Joyful View Subdivision Final Drainage Report

May 2026

PCD File No. SF2231

DETENTION BASIN STAGE-STORAGE TABLE BUILDER

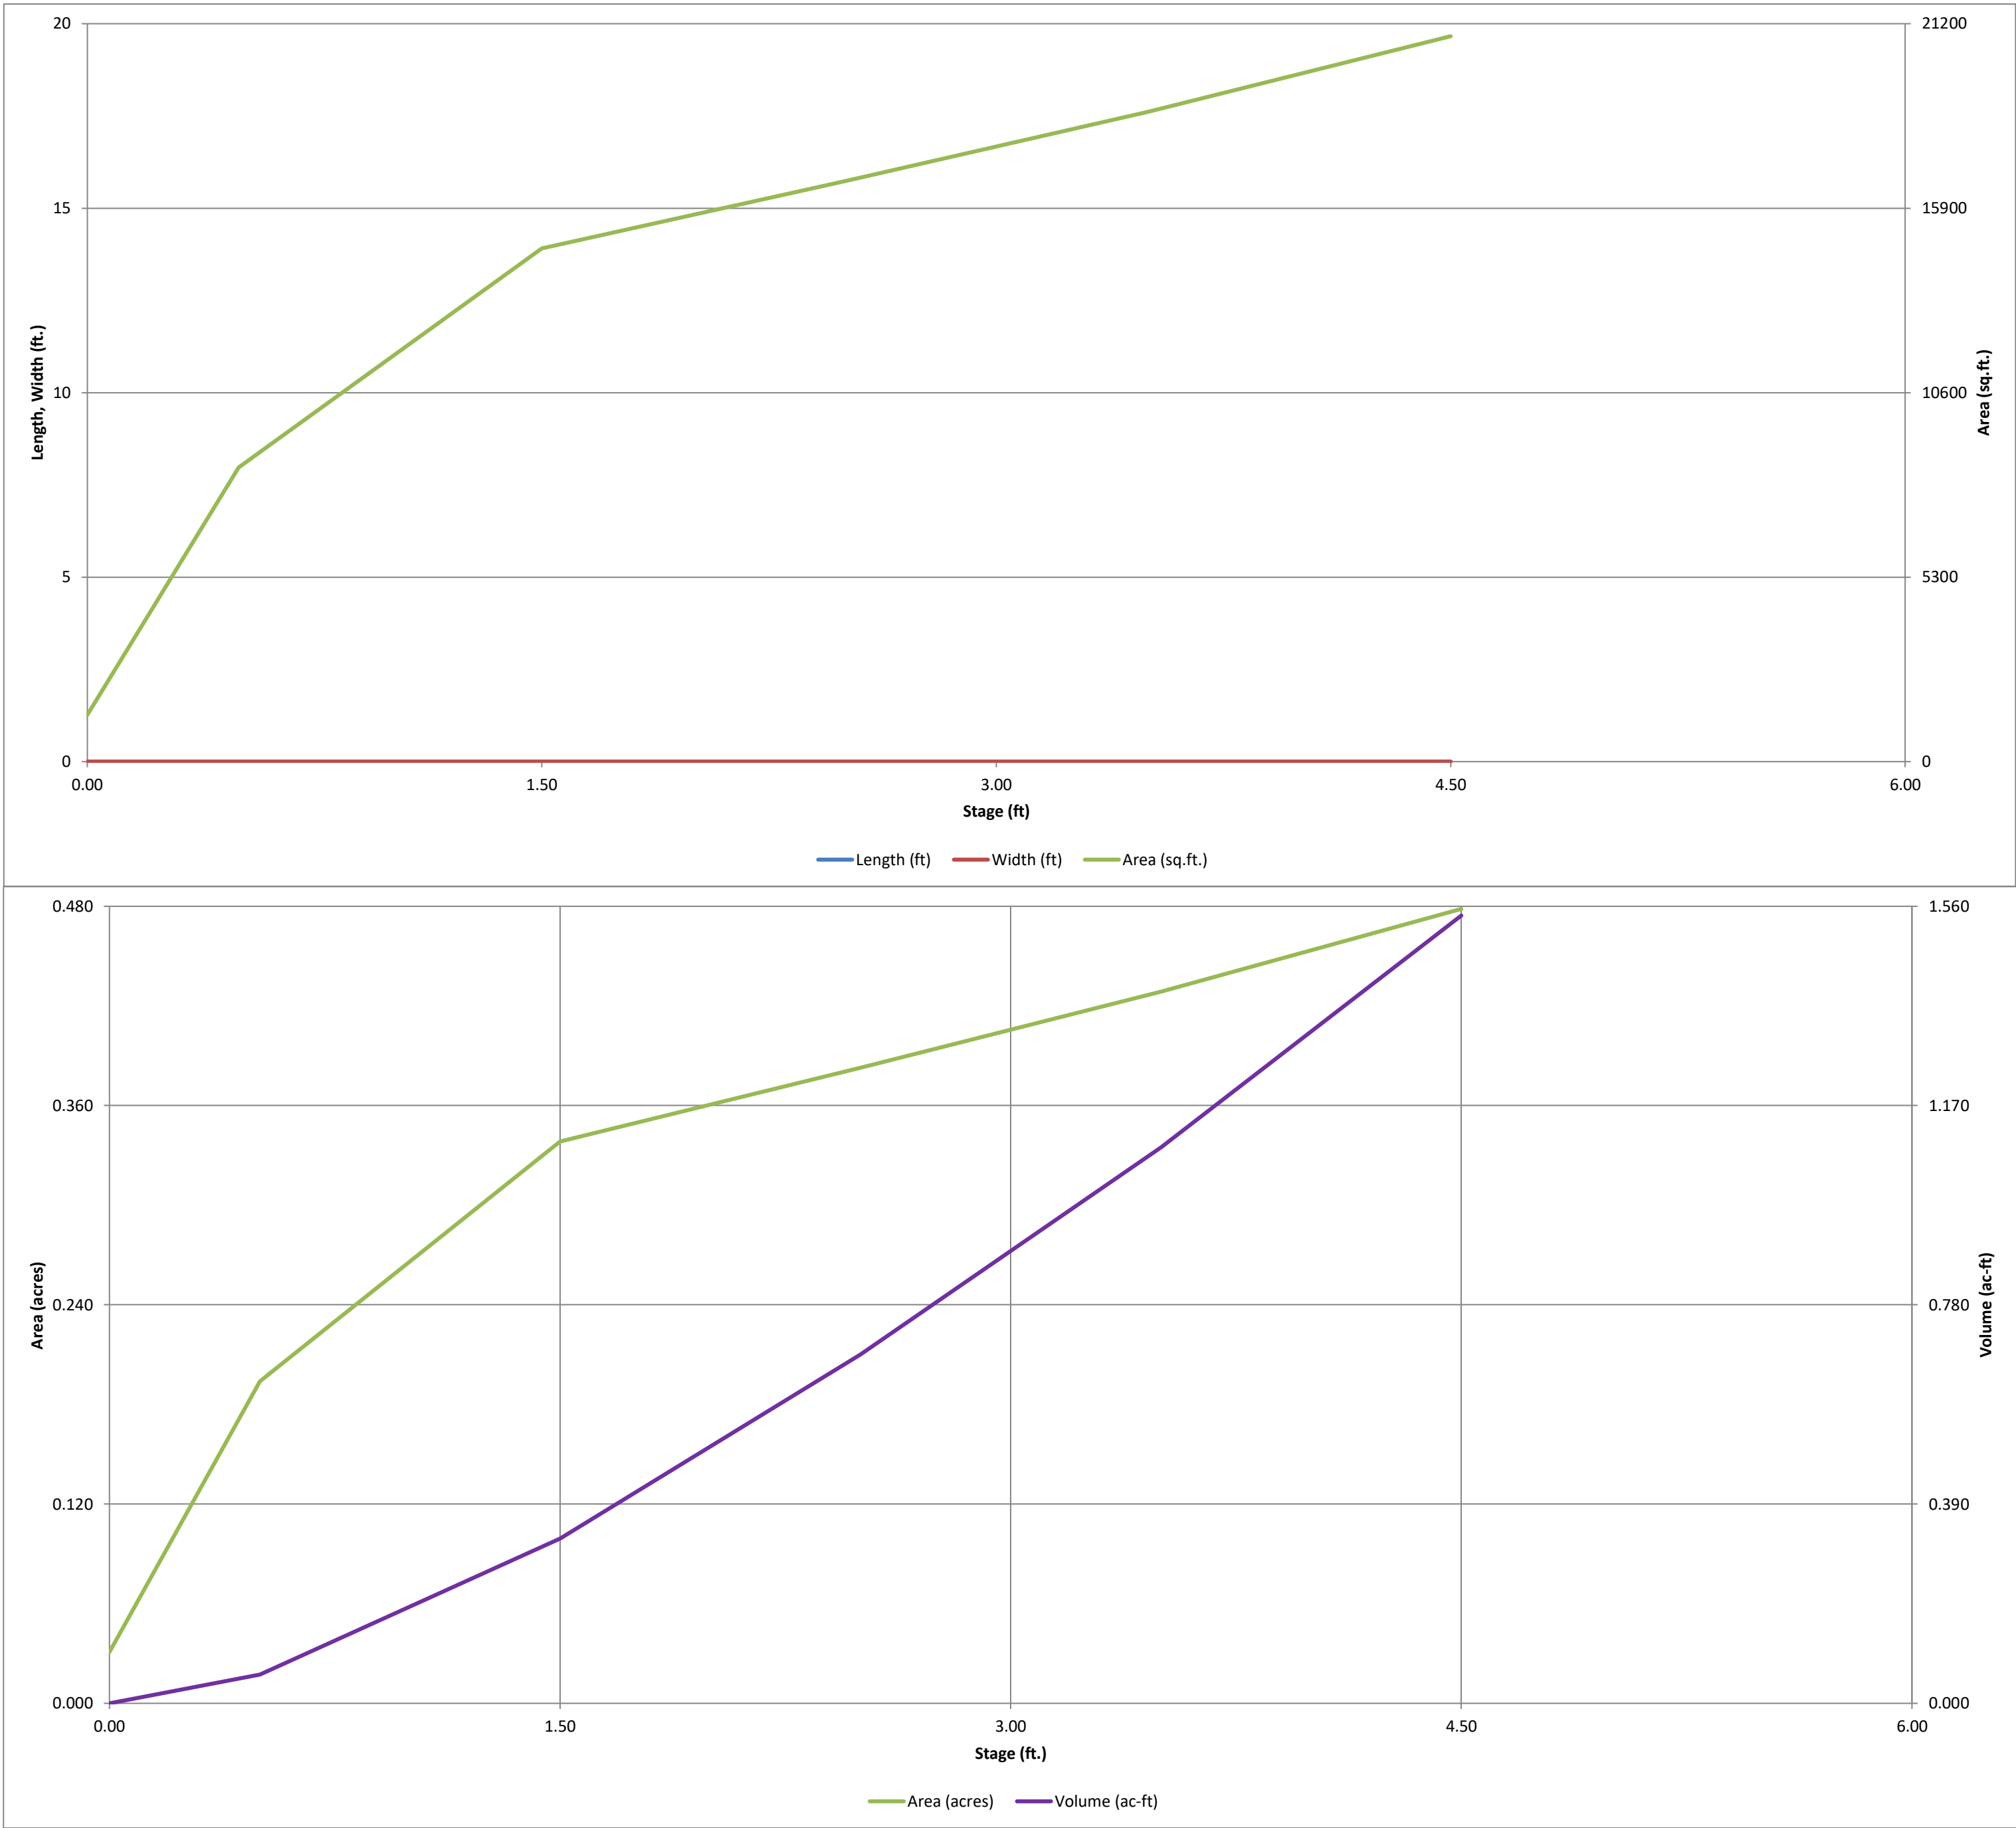
✓ = calcs match details in plans
✗ = calcs do not match details in plans

DETENTION BASIN OUTLET STRUCTURE DESIGN

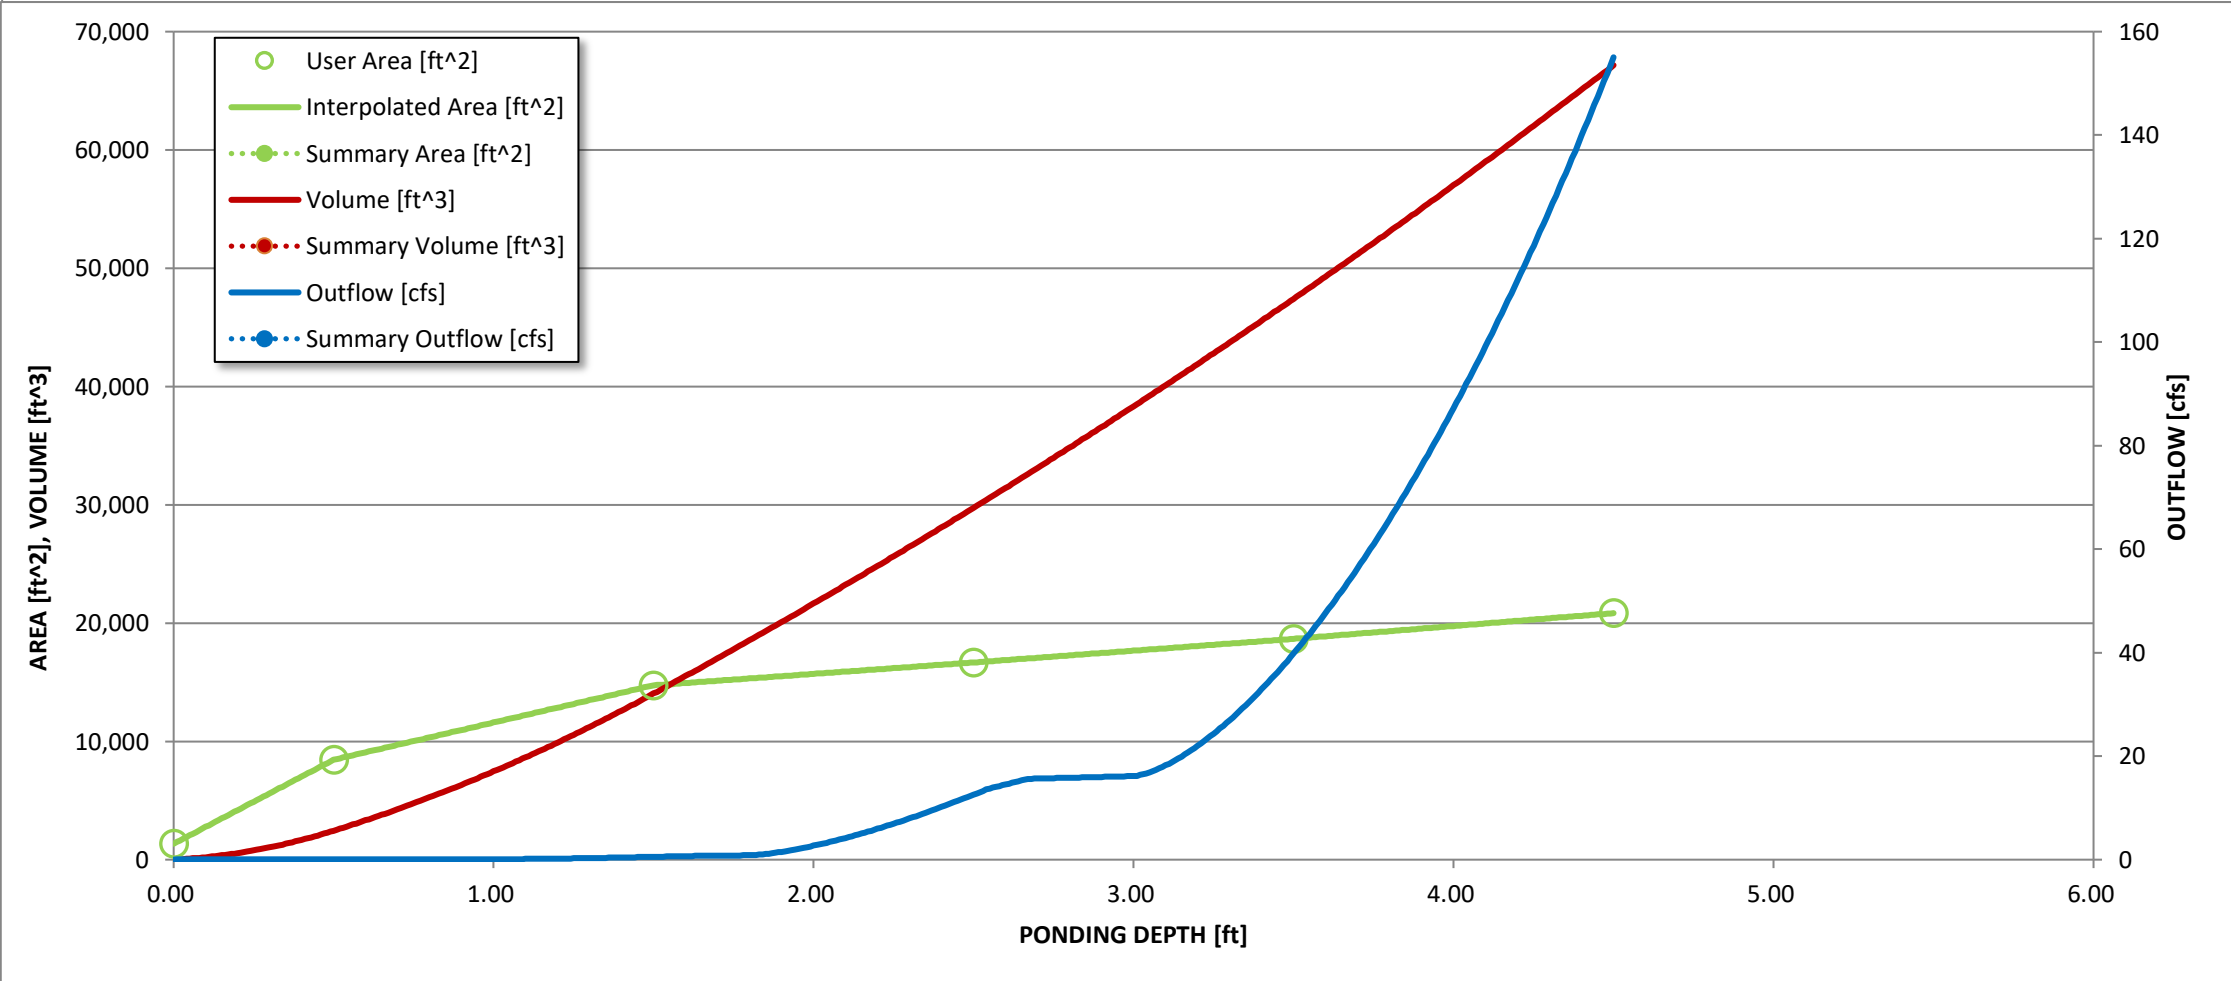
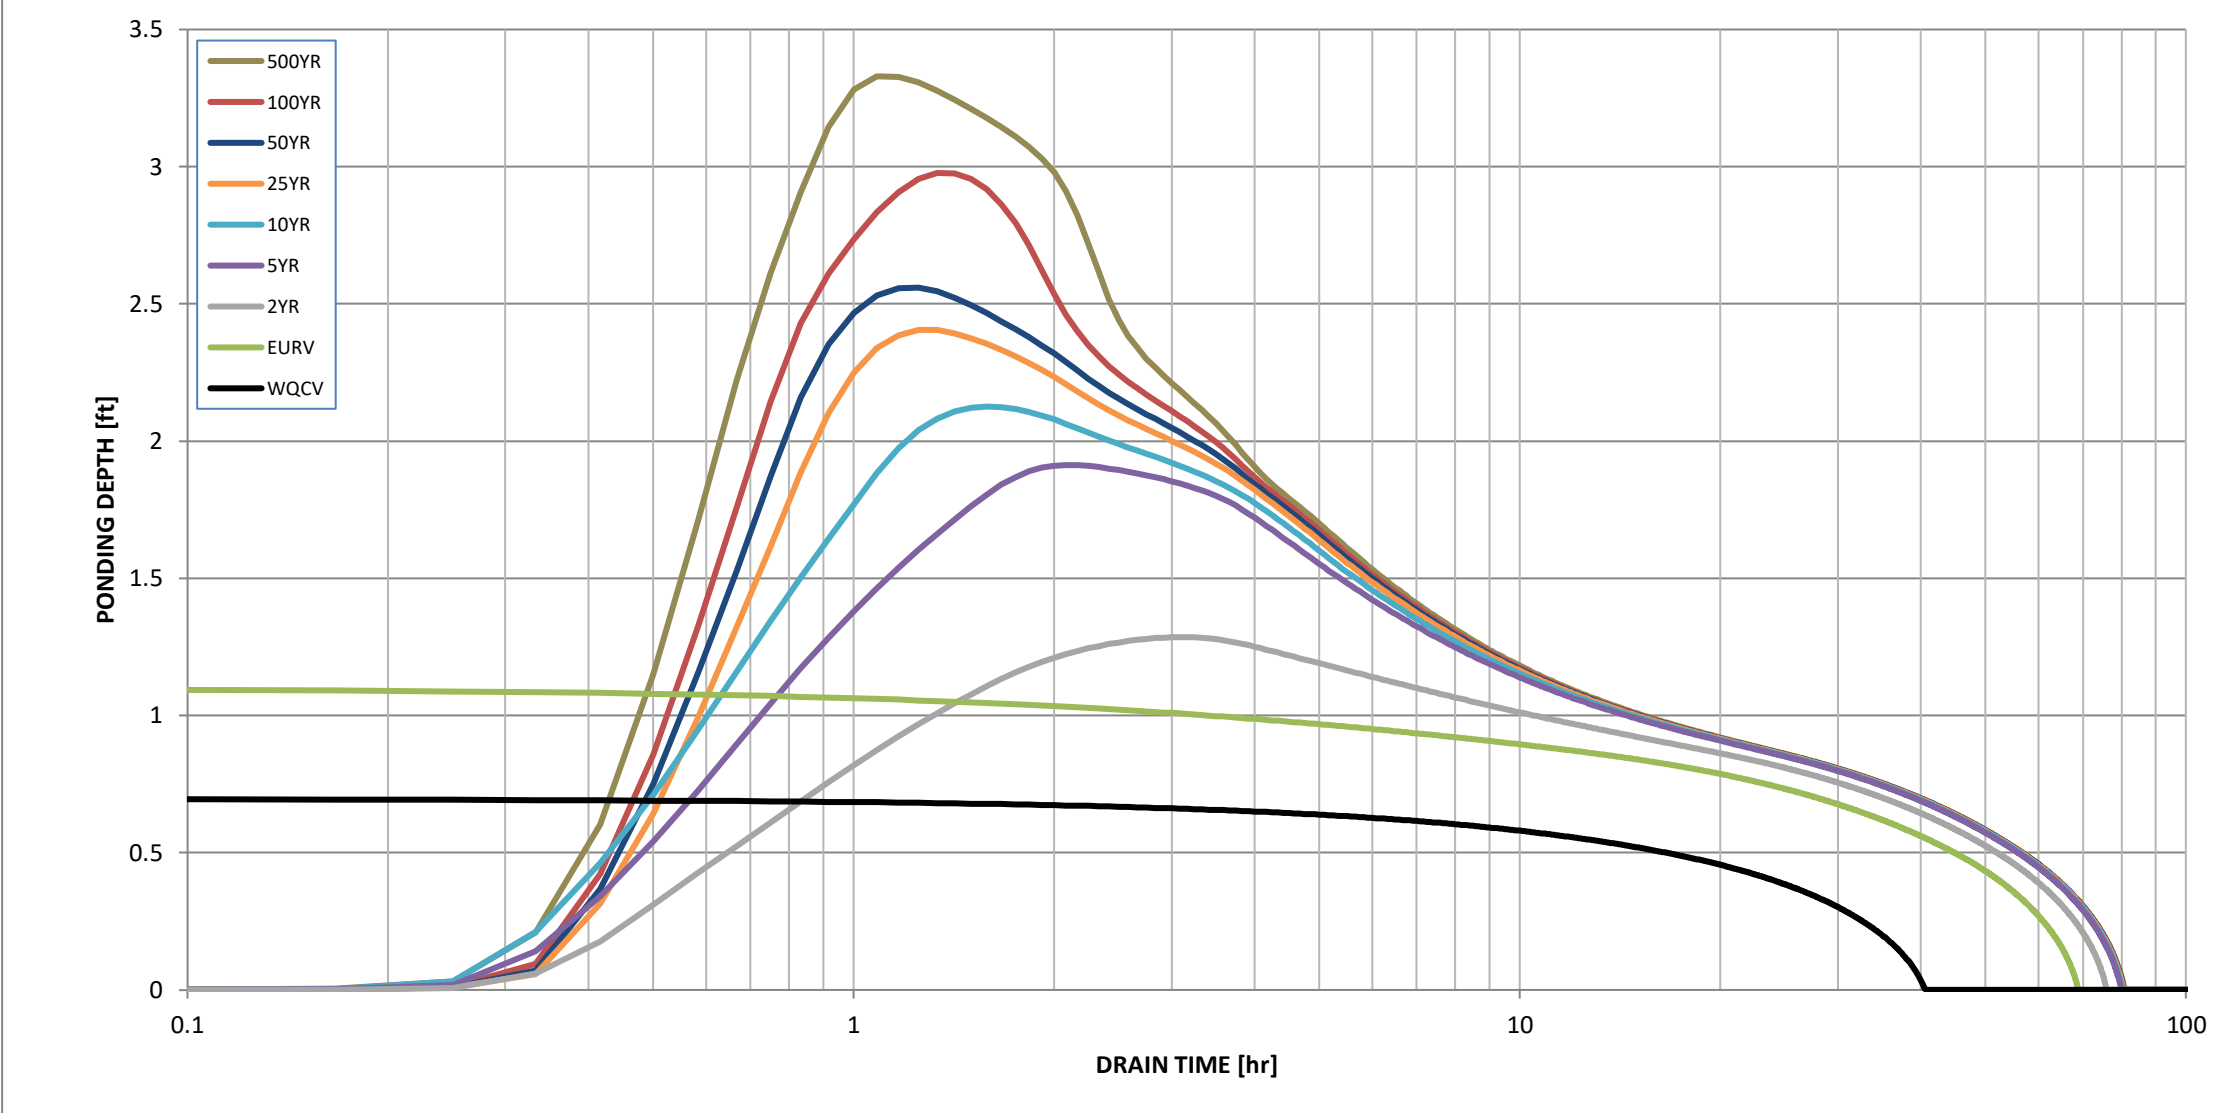
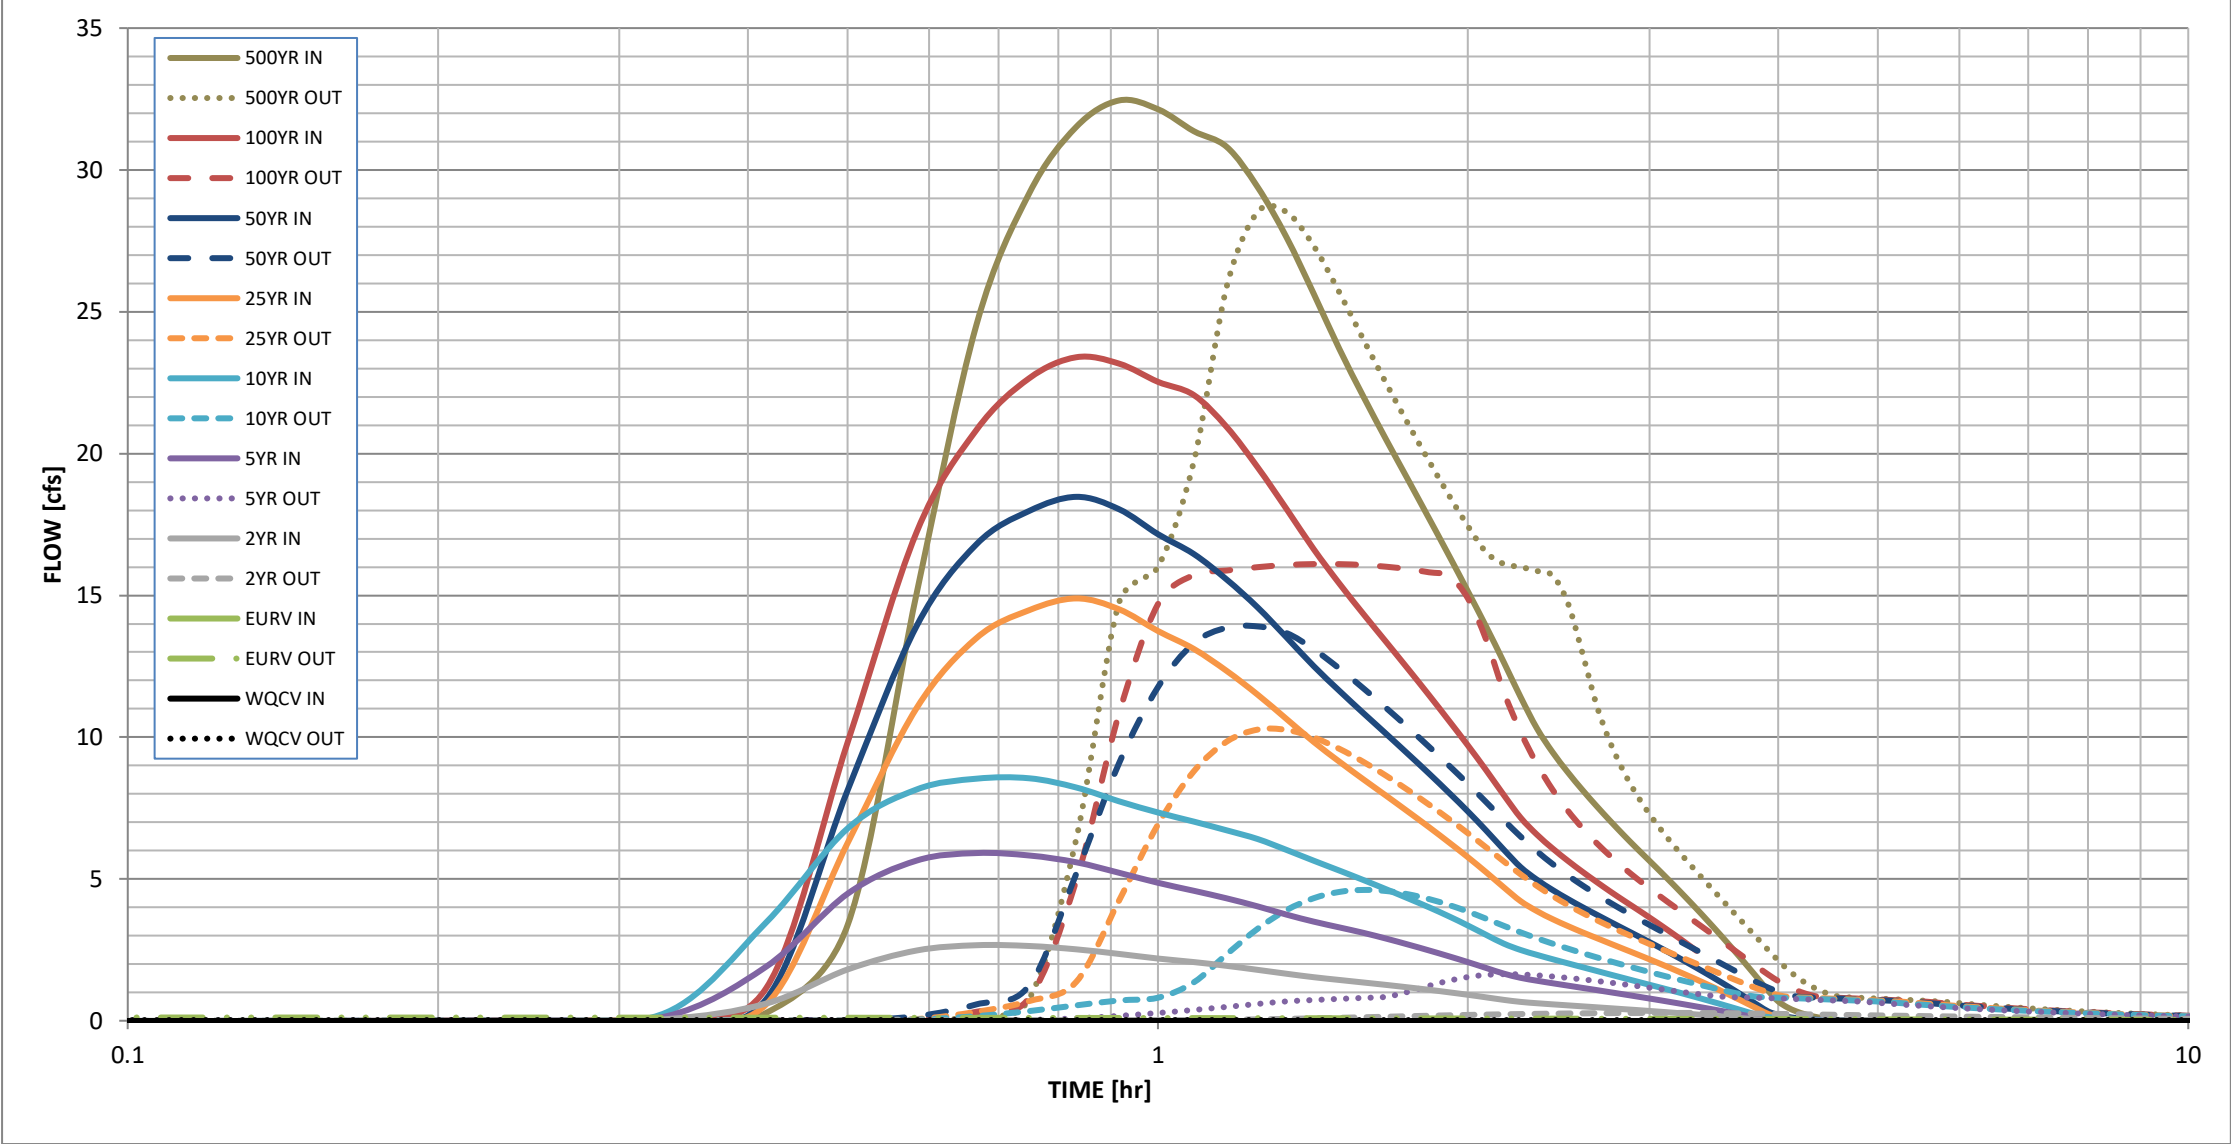
16.1 max
